ON-SITE SEWAGE DISPOSAL SYSTEM
HOWARD COUNTY HEALTH DEPARTMENT
BUREAU OF ENVIRONMENTAL HEALTH

ADDRESS: 6836 Mink Hollow Road PROPERTY OWNER: Mark & Patricia Hasegawa

SCALE 1" = 100'	DATE OCT. 29, 2004	ROBERT H. VOGEL ENGINEERING, INC. ENGINEERS - SURVEYORS - PLANNERS 8407 MAIN STREET ELLCOTT CITY, MARYLAND 21043 TEL: 410.461.7666 / FAX: 410.461.8961	WALL CHECK DRAWING 6836 MINK HOLLOW ROAD TAX MAP 40, GRID 2, PARCEL 31 5TH ELECTION DISTRICT HOWARD COUNTY, MARYLAND
DRAWN BY B. ABBOTT	CHECKED BY M. MARTIN		
PLAT NUMBER	JOB NUMBER 04-108.00

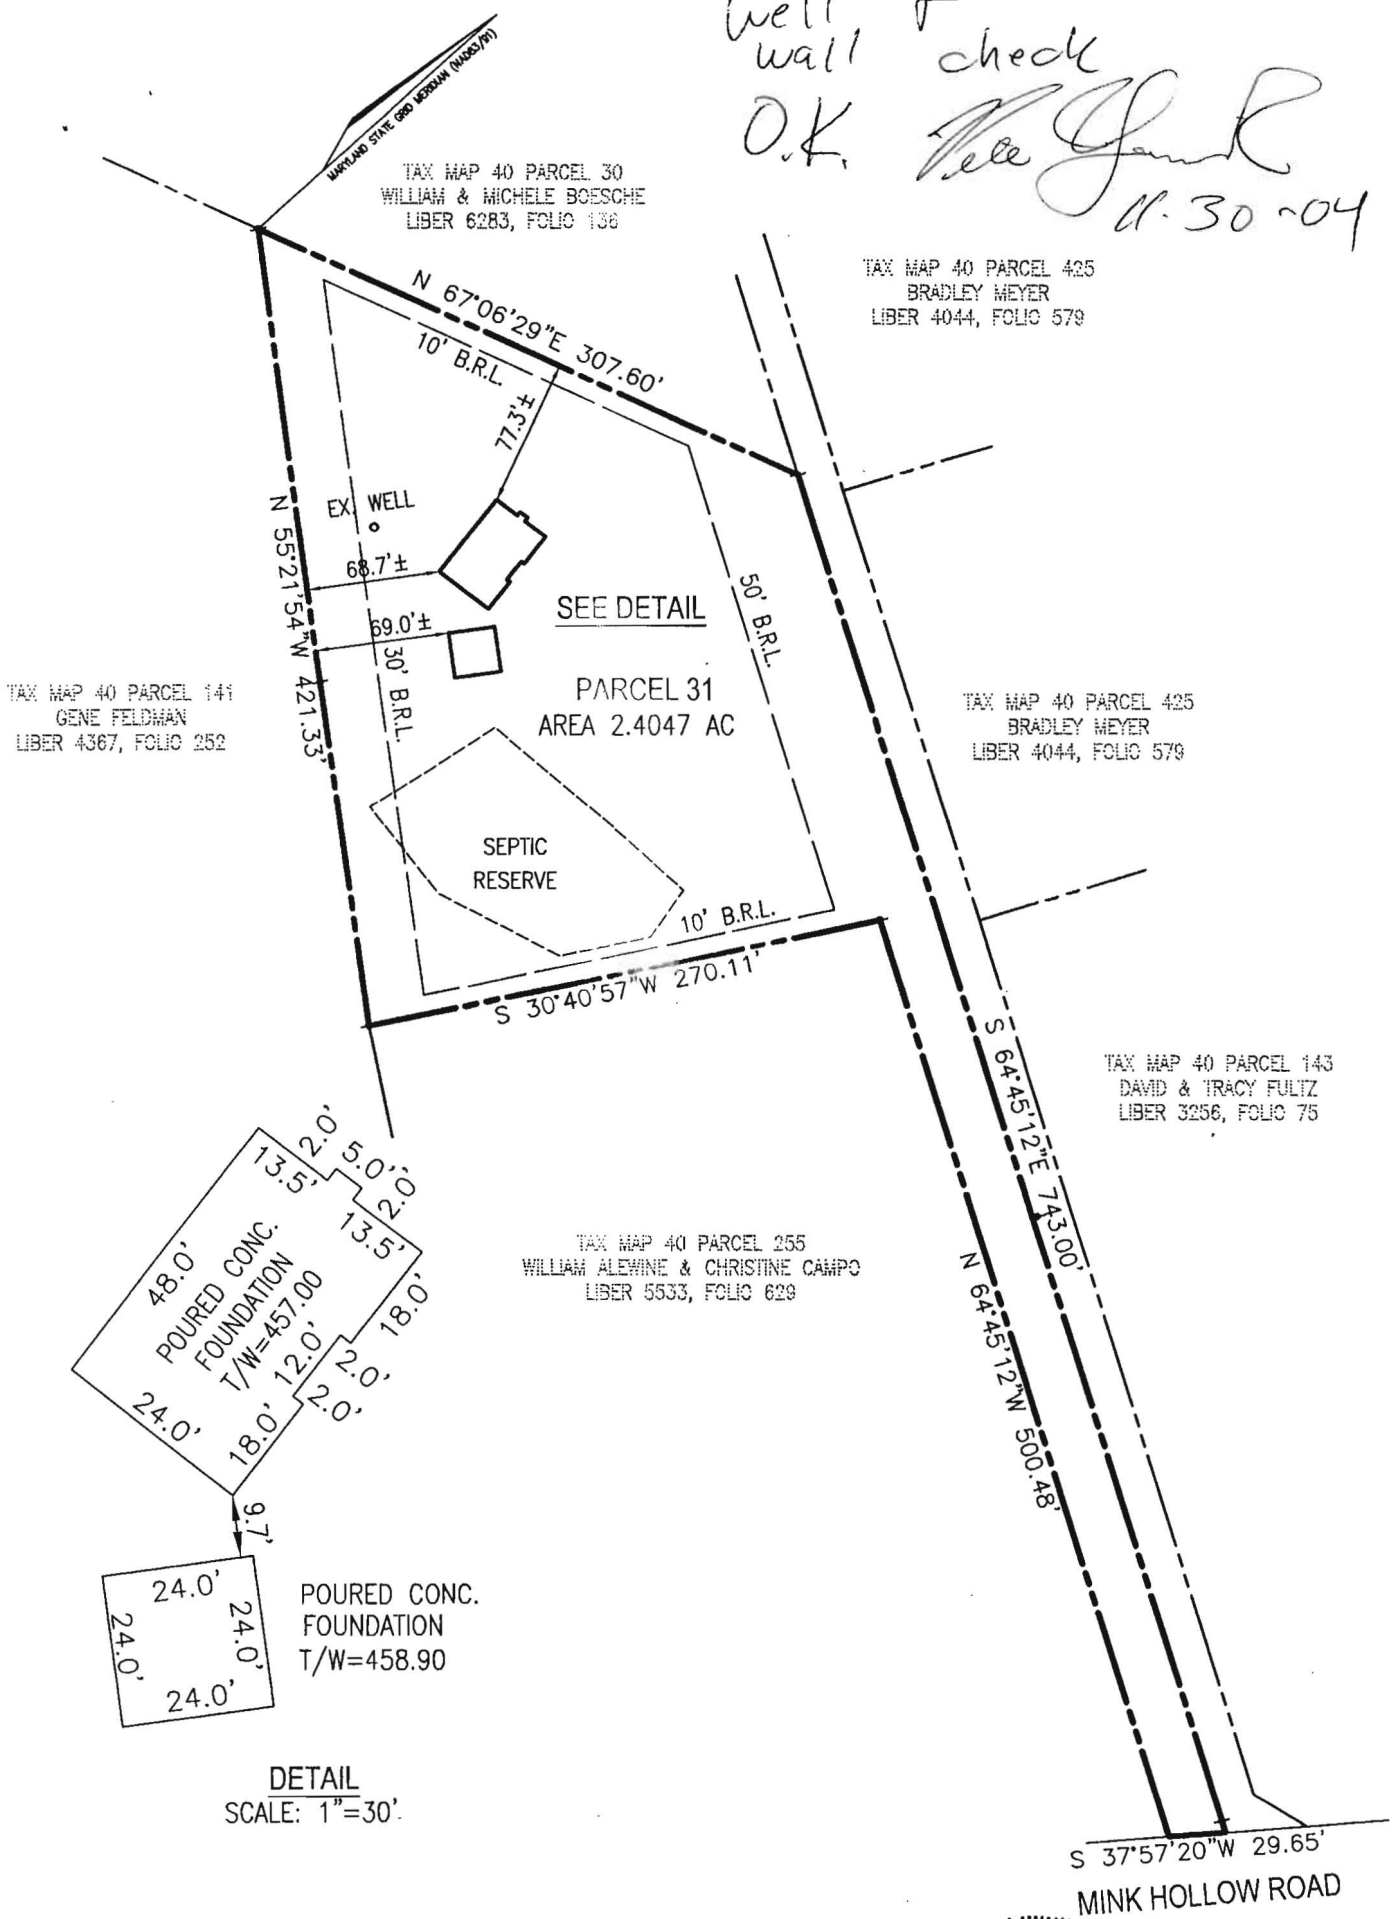
PRE-CONSTRUCTION 12/9/04 - SRA changed by KN. Cont. & Bu. lda did not know. Install 50' & 70' trenches as far up in

INSTALLATION corner of lot as possible, 10' off lot lines, 12' CTG (50)

12/13/04 Tanks set. Trenches installed. Need tank cleanouts and baffles. Pump and alarm test required for final approval. (BB)

2/10/05 Pump and alarm working. Everything else O.K. (BB)
